# AMENDMENT

## TBR 3

## A1

# Integrated Services Digital Network (ISDN);
# Attachment requirements for terminal equipment to connect
# to an ISDN using ISDN basic access

**Figure B.40: Test configuration**

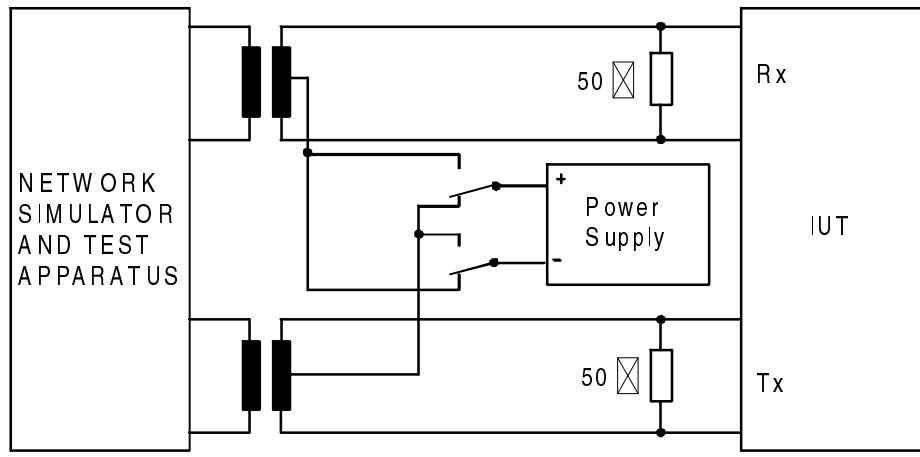
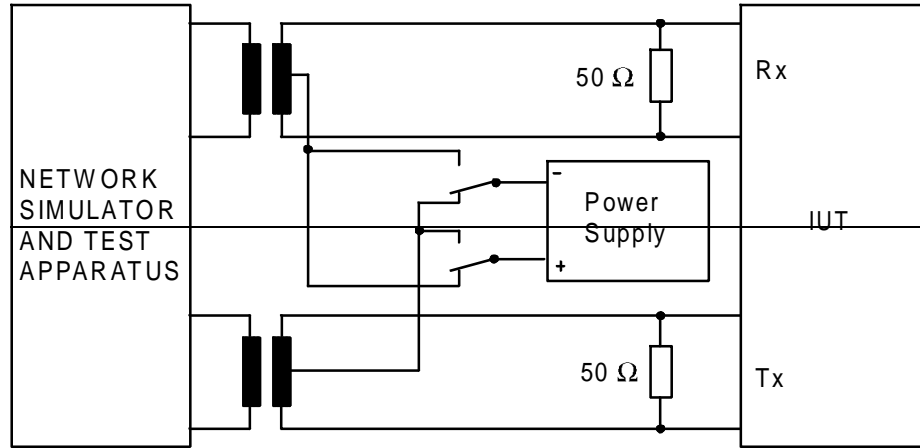
**Page 355, subclause B.5.4.5.2, figure B.40**
